IAI WESTWIND

SERVICE BULLETIN

INDEX

FIGURE 1: VERTICAL GYRO INSTALLATION.
 -RE 1: Single Instl
 -RE 3: Dual Instl. (1 of 2)

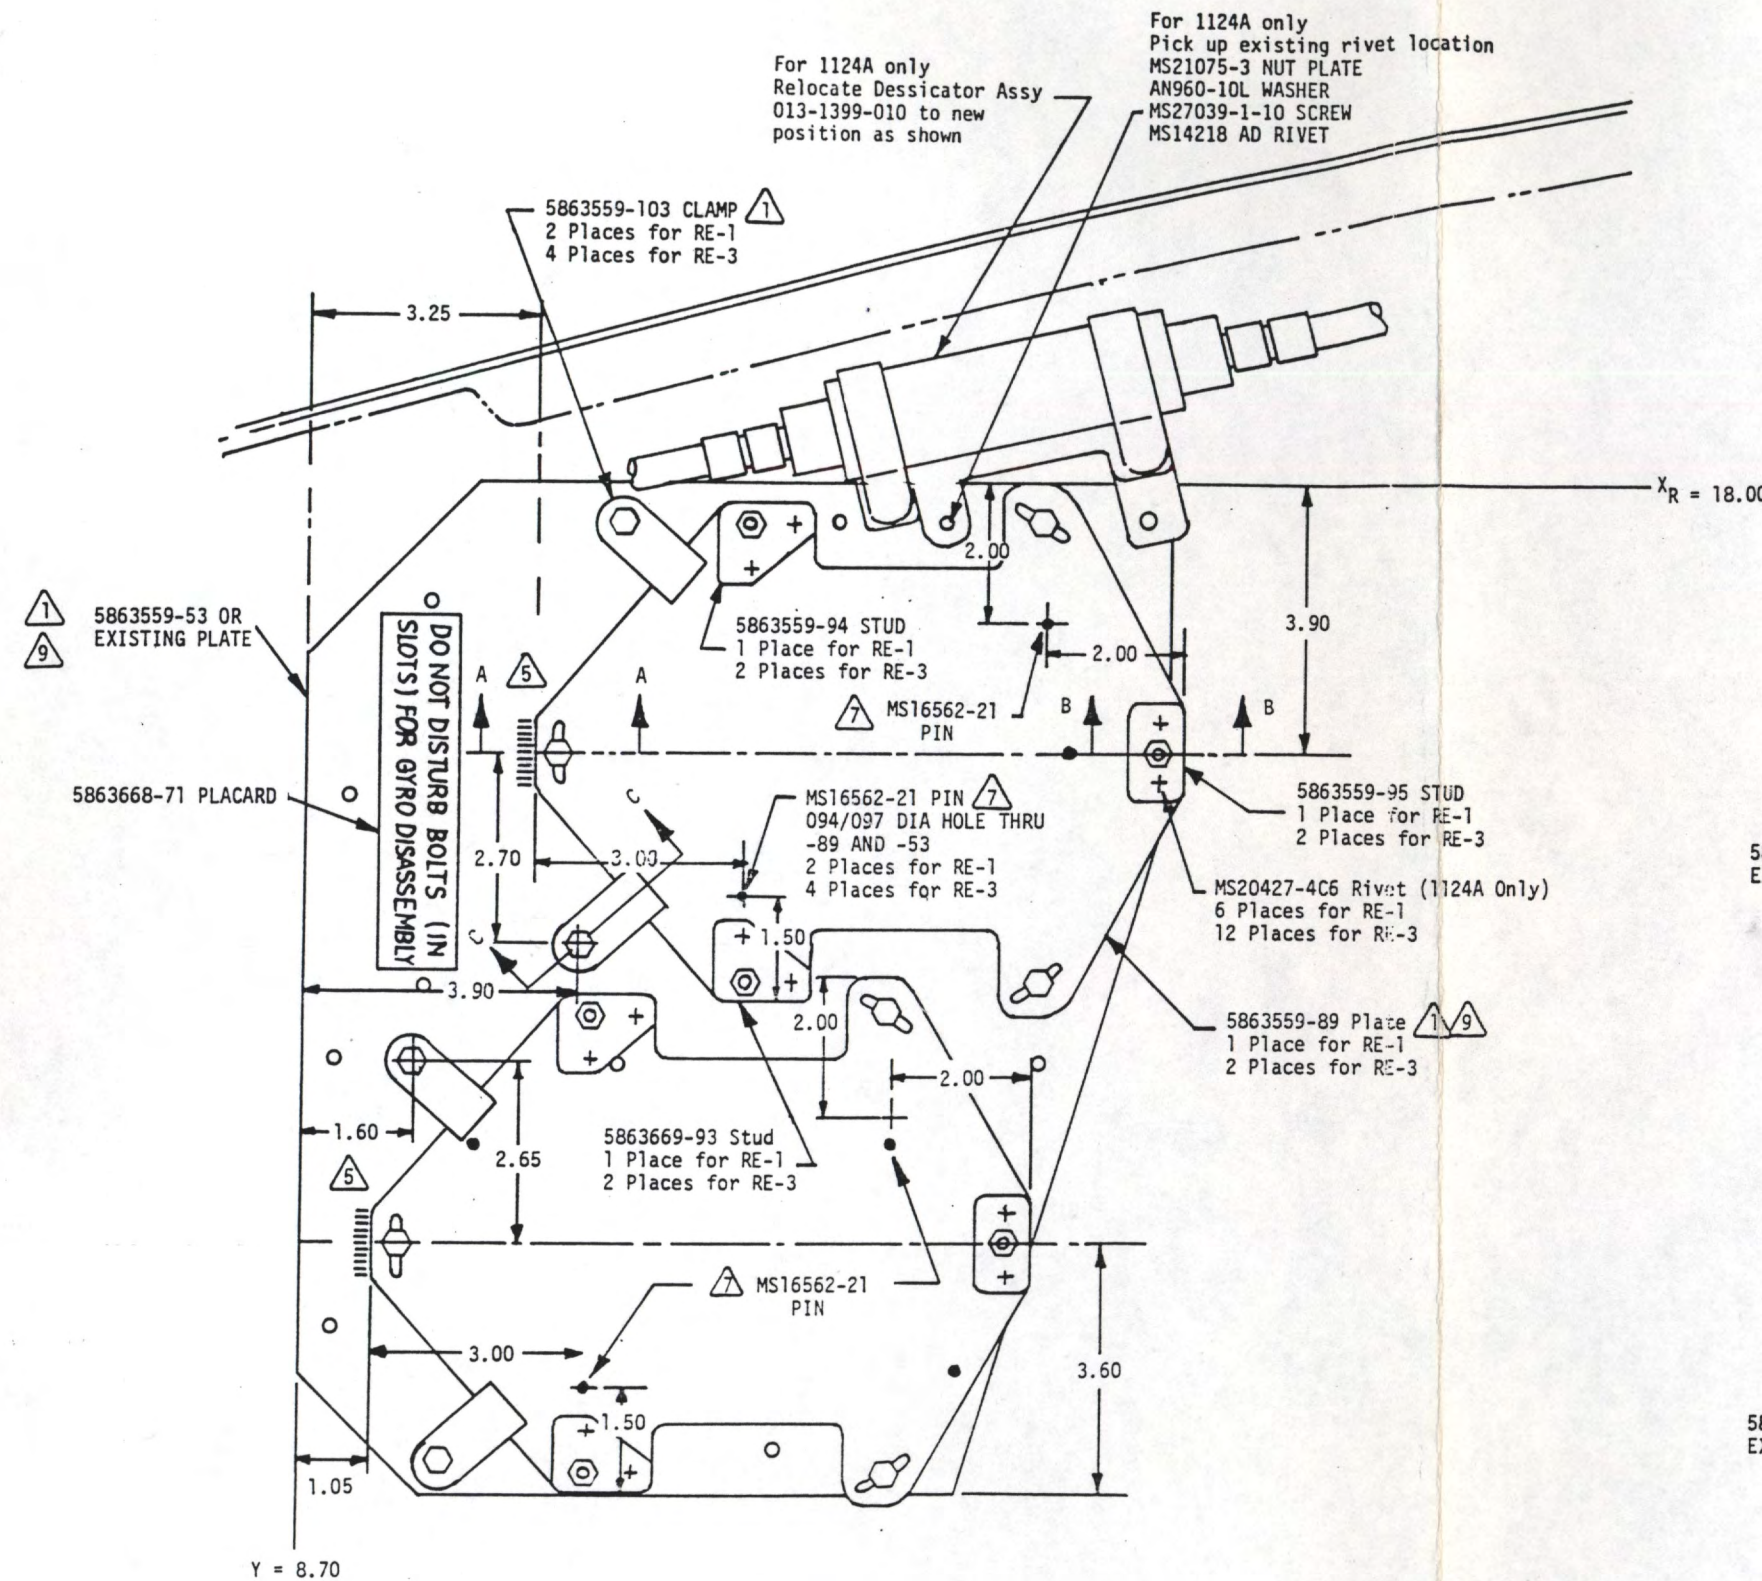
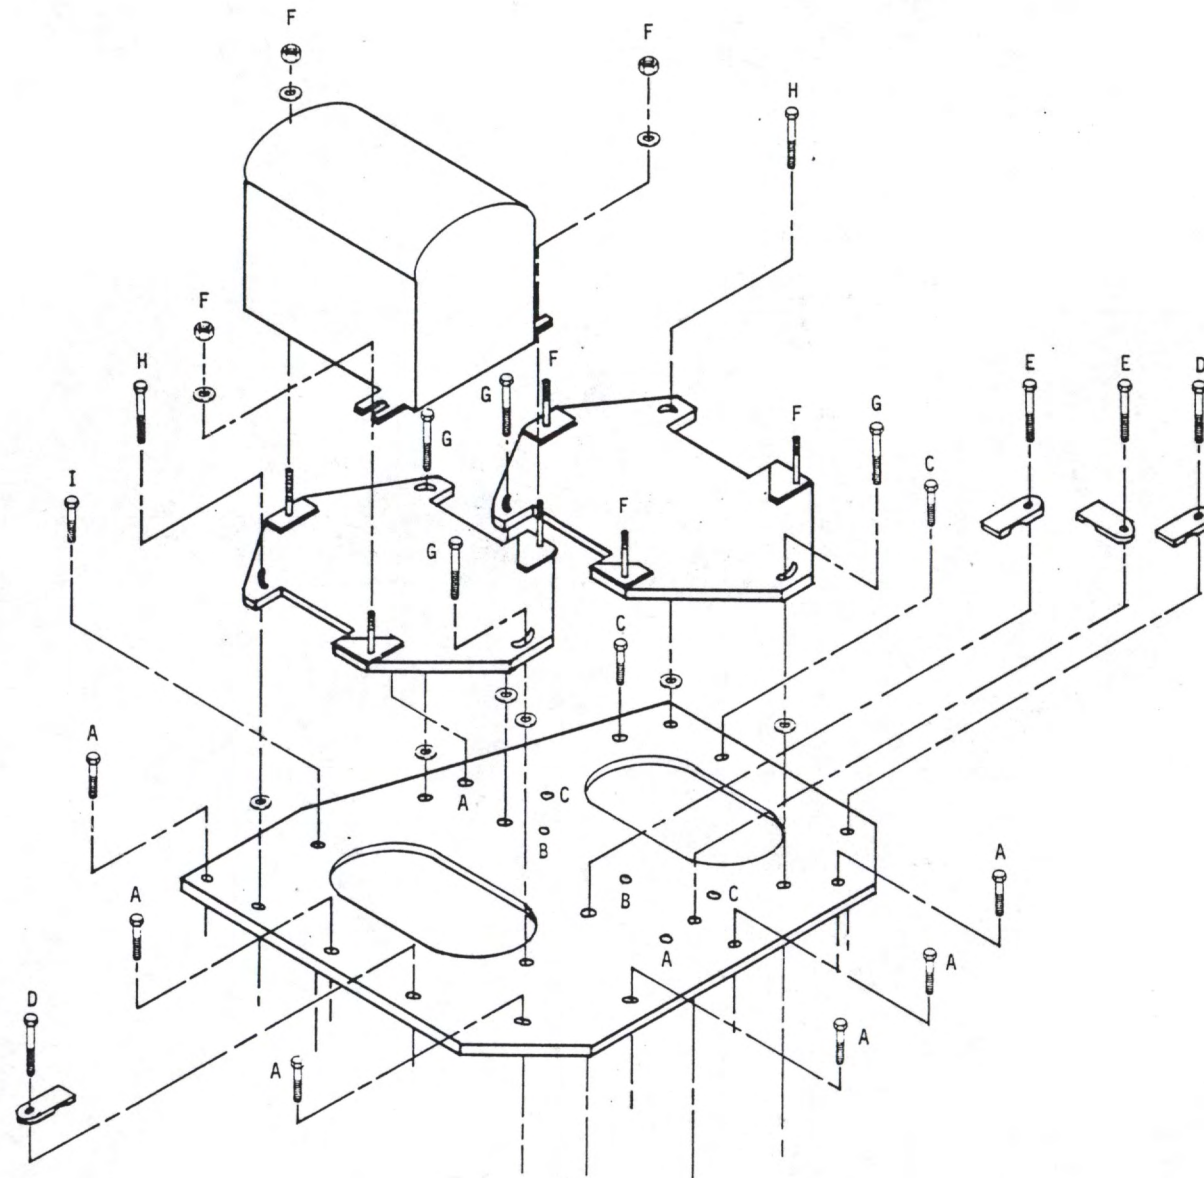
- E. Install P/N 5 863559-53 base-plate, P/N 5 863559-89 skew-plate assembly(s) and P/N 5 863559-103 clamps per Figure 1. Install nut-plates through oxygen bottle access cover or nose deck structure only (not through P/N 5 863559-53 base-plate) using MS14218AD rivets.

If skew-plate(s) are 1/8 inch in thickness, drill out rivets securing the three stud assemblies per plate and replace them with one each P/N 5 863559-93, 94, 95 per skew-plate using MS20427-4C6 rivets (Figure 1).

- F. Lay out and install P/N MS21075-3 nut-plates per Figure 1 using MS14218AD rivets. Install all nut-plates on bottom of nose deck structure and bottom of oxygen bottle access cover (not on P/N 5 863559-53 base-plate).

- G. Install oxygen bottle access cover base, plate P/N 5 863559-53, skew-plate(s) P/N 5 863559-89, and clamps P/N 5 863559-103. Refer to Figure 1 for hardware information as well as which base-plate holes require countersinking.

- H. Relocate desiccator assembly per Figure 1.
- I. Reinstall gyro(s) and level per Service Information Letter No. 1124-22-038 "Vertical Gyro Adjustment Procedure." Leveling can be accomplished by adding AN960-PD10L washers under the gyro mounts (Figure 1, Section B-B). Grind washer faces as required to achieve proper thickness.

Figure 1 of 3

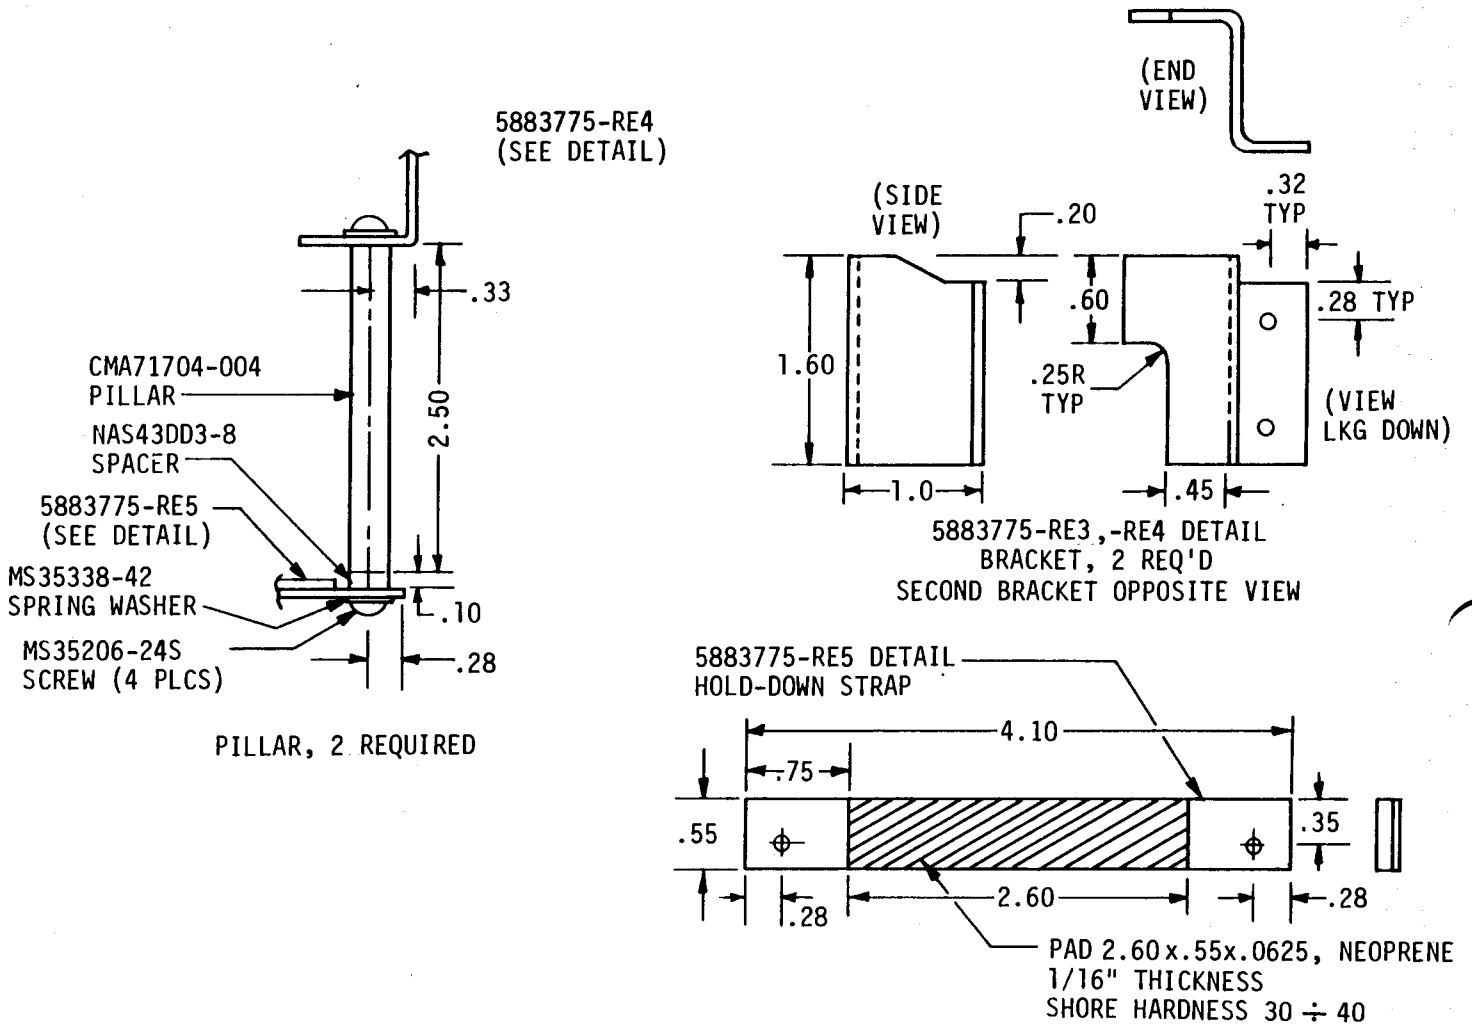
- (3) Remove existing diode board mounting brackets from stand-offs and discard brackets (retain hardware for following steps). Refer to Figure 1.
 - (a) Use brackets P/N 5883775-RE3 and 5883775-RE4 or locally fabricate new mounting brackets from standard and 10139-070-1 stock ALCLAD 2024-T3511 (two required - second (5883775-RE4) bracket opposite of Figure 1 view).

- (b) Use bracket P/N 5883775-RE5 or locally fabricate hold-down strap from .063 ALCLAD 2024-T6 stock per Figure 1.
- (4) Secure new brackets in place on instrument panel using hardware from step (3) above.

- (b) Drill holes in brackets and mount PCB receptacles using Loctite on screw threads. Mount pillars in same manner with screws and spring washers as shown on Figure 1.

Figure 2 of 3

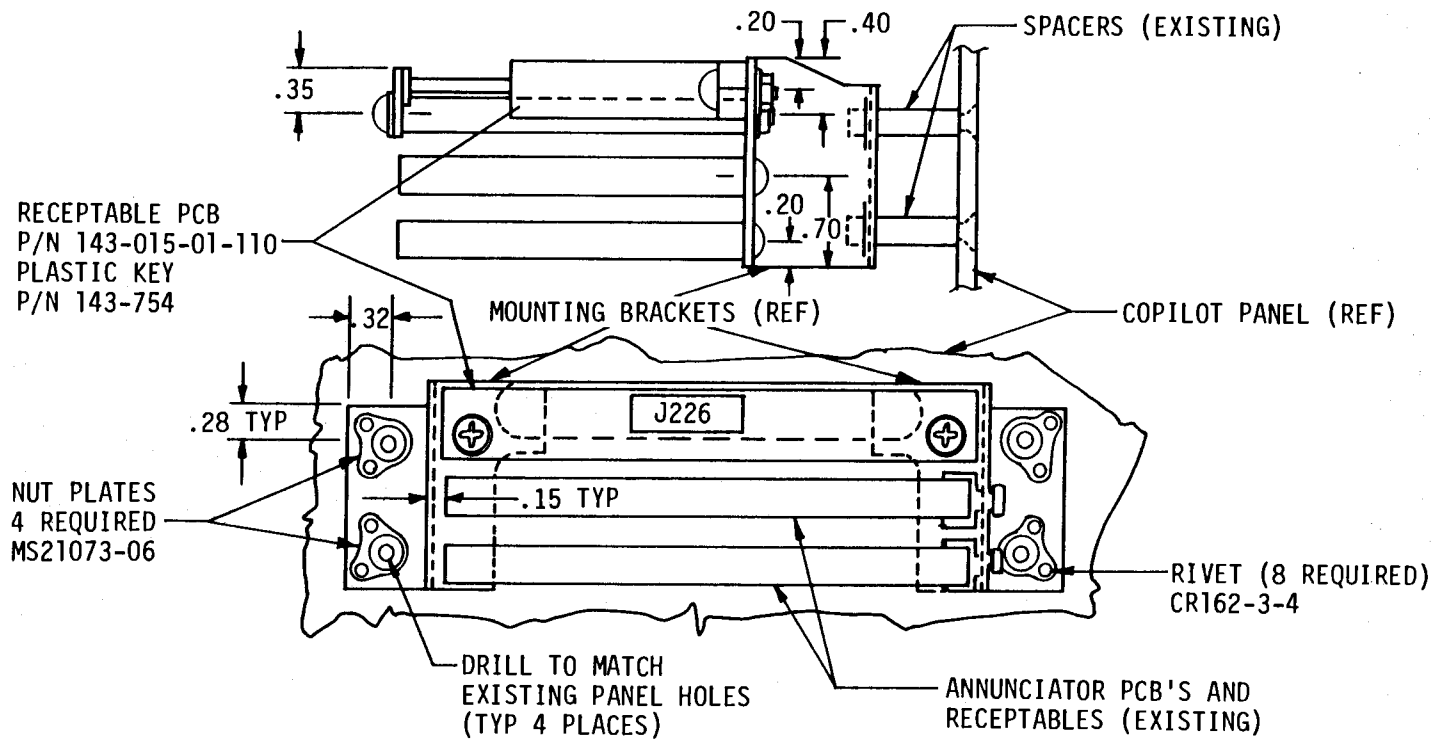
- (a) Align printed circuit board (PCB) receptacles on mounting brackets as per Figure 2 and mark brackets for drilling of mounting holes. Follow same procedure for pillars used for securing regulator board.

Figure 3 of 3

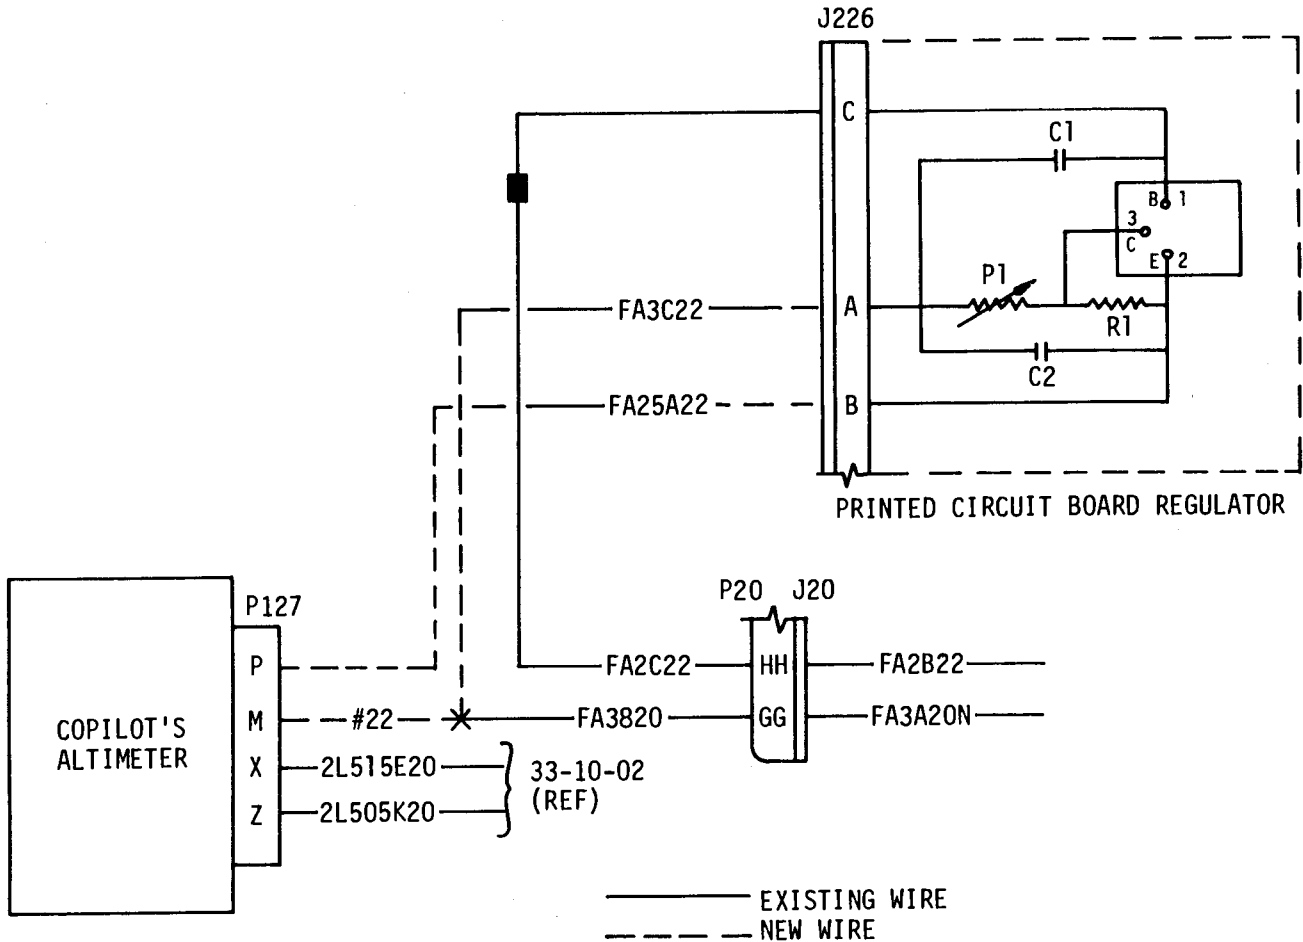
- (c) Install new PCB and hold-down strap. Label PCB receptacle as "J226."
- (5) Perform wiring changes per Figure 3.
- (6) Reassemble copilot's instrument panel.

VIEW LOOKING OUTB'D R.H.S.
FIGURE 1

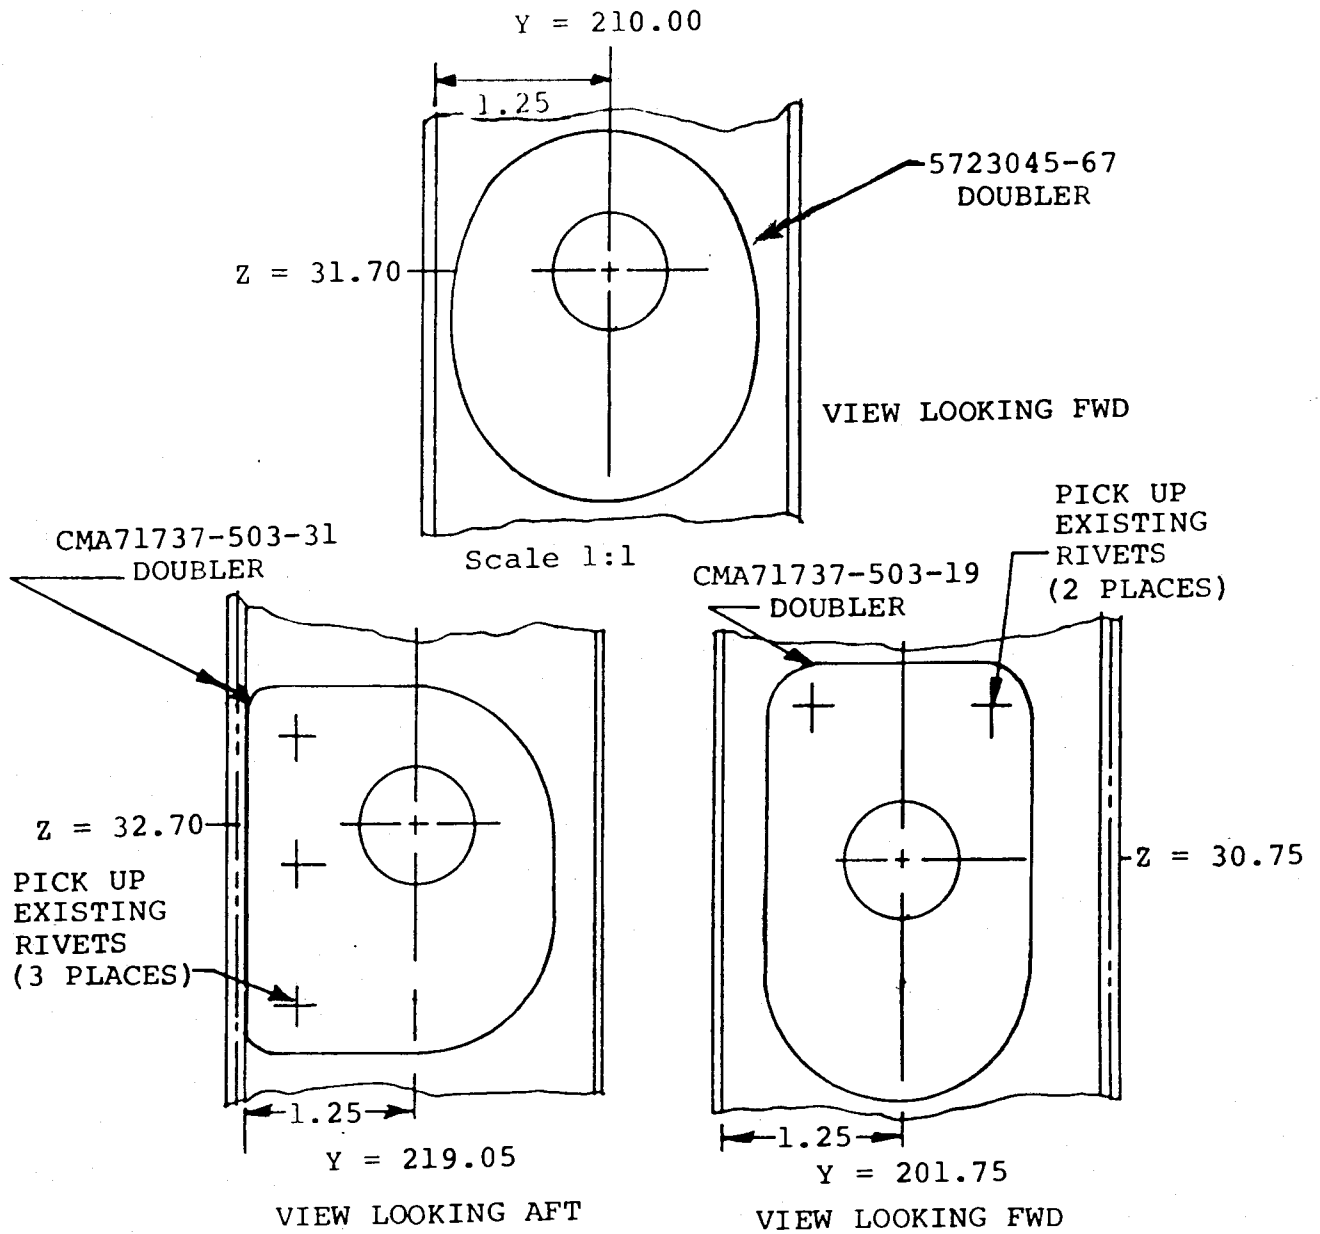
- (1) Disconnect tube at tee fitting adjacent to static port and at elbow fitting between frame Stations 219.05 and 223.75. Refer Figure 1.
- (2) Remove clamps supporting tube and remove tube.
